# BOTANY RAIL DUPLICATION

## SUBMISSIONS REPORT

MARCH 2020

Client: Australian Rail Track Corporation  
Title: Botany Rail Duplication  
Subtitle: Submissions Report  
Document No: BRD-G2S-SN-RPT-0001- 13  
Date: 4 March 2020

**Figure 4.3** Revised plan of the proposed Mill Stream bridge

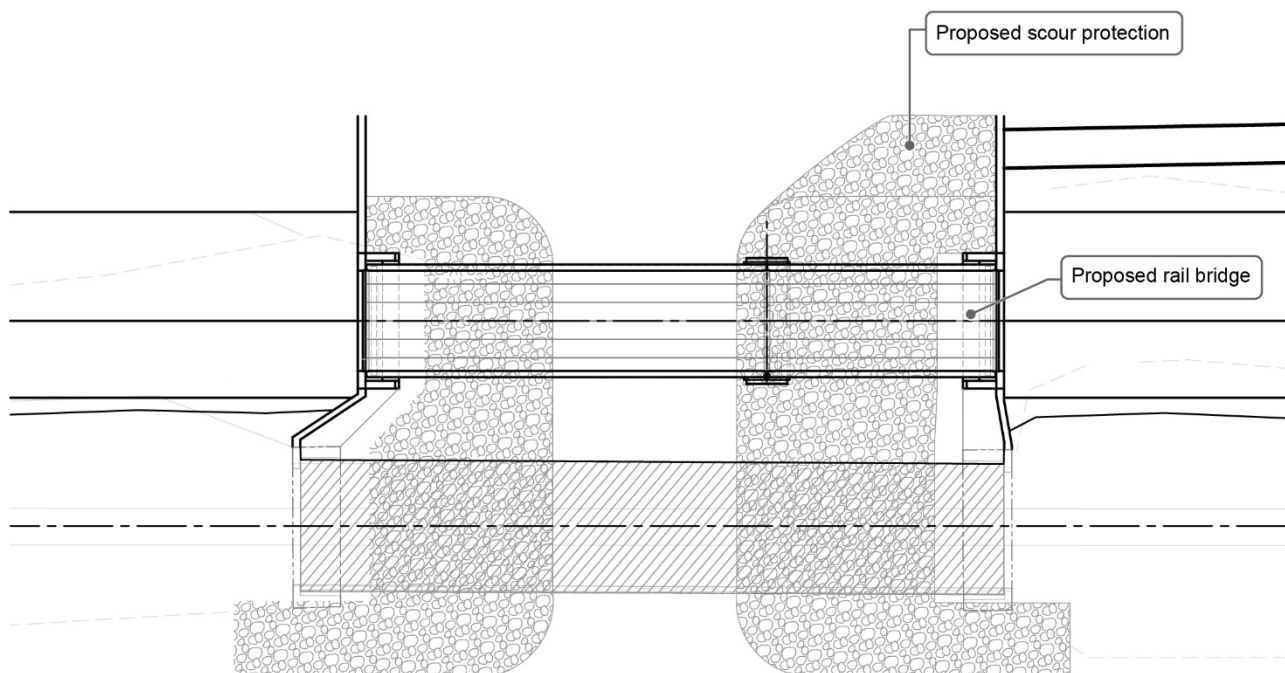
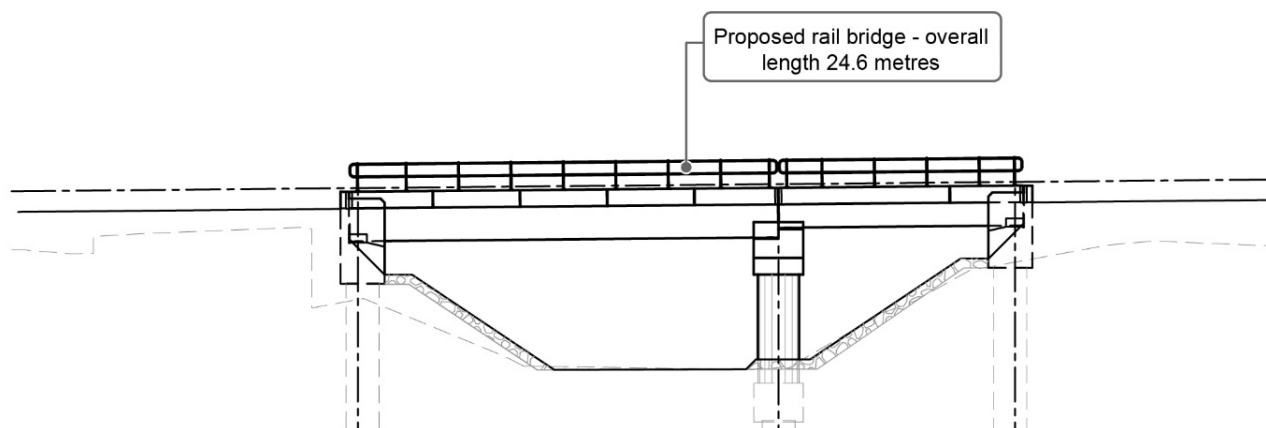
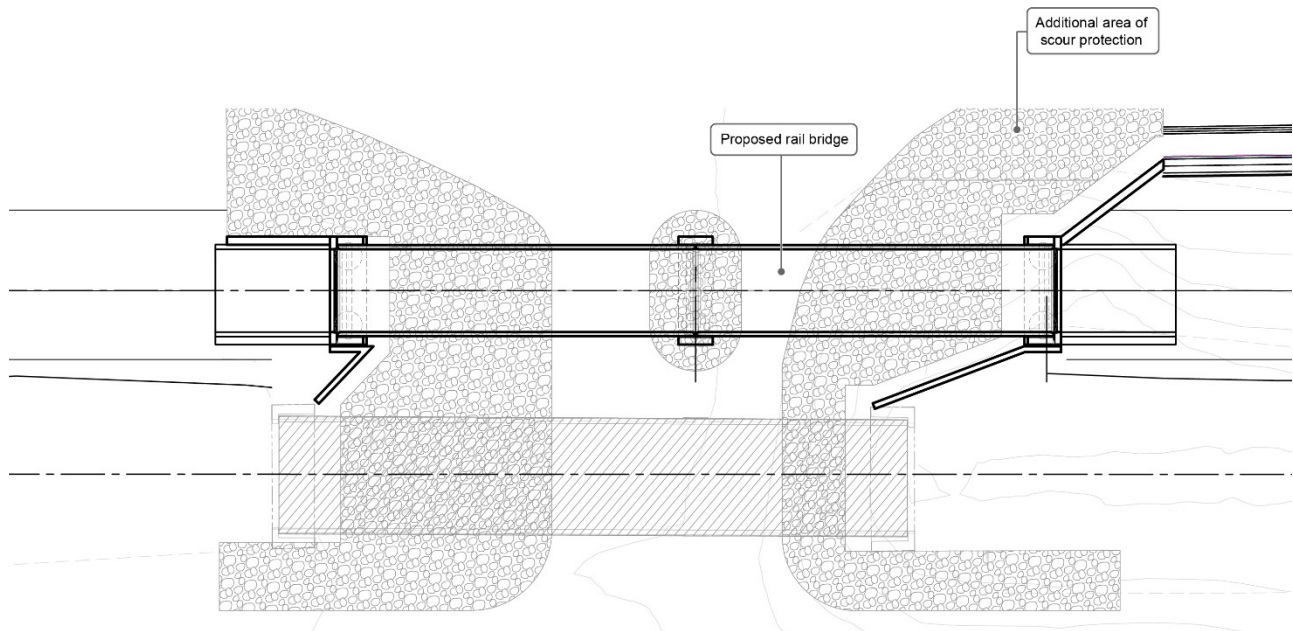
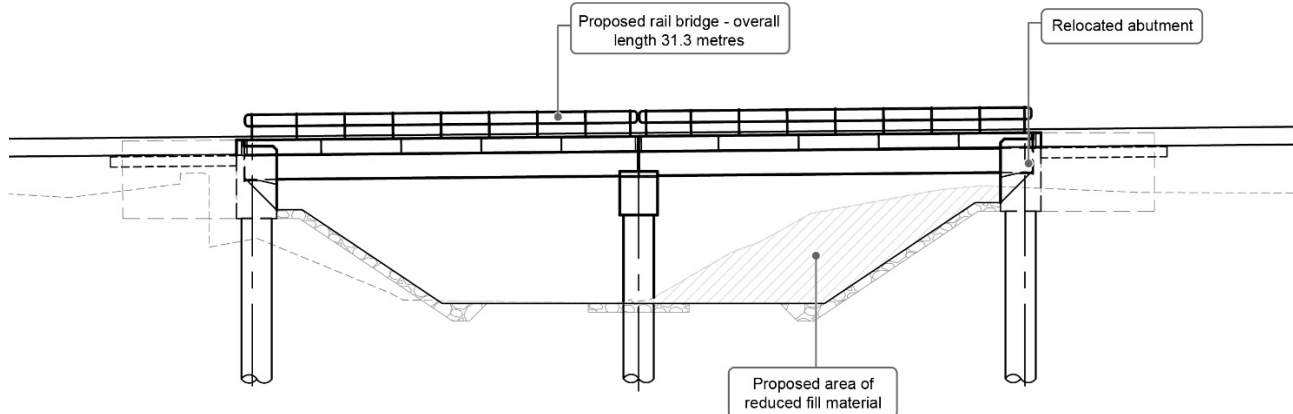
A plan of the proposed design of the EIS project for the Mill Stream bridge is shown in Figure 4.1 with an indicative elevation shown in Figure 4.2.

The key impacts identified for the proposed additional bridge structure included biodiversity impacts associated with the vegetation clearing required to accommodate the proposed structure and a minor increase in peak flood levels during the 1% AEP event upstream of the bridge.

The proposed design change would include extension of the proposed bridge deck (western span) by around seven metres and relocation of the western abutment to support the proposed design change. The western abutment would be set back in order to increase the overall cross section area of the flow path of flood waters beneath the proposed underbridge. This was identified as being required to mitigate the impacts of excessive water flows observed as part of the flood modelling results during the 1% AEP event that were identified for the EIS project design (refer above).

An indicative plan for the revised bridge design is shown in Figure 4.3 with an indicative section shown in Figure 4.4.
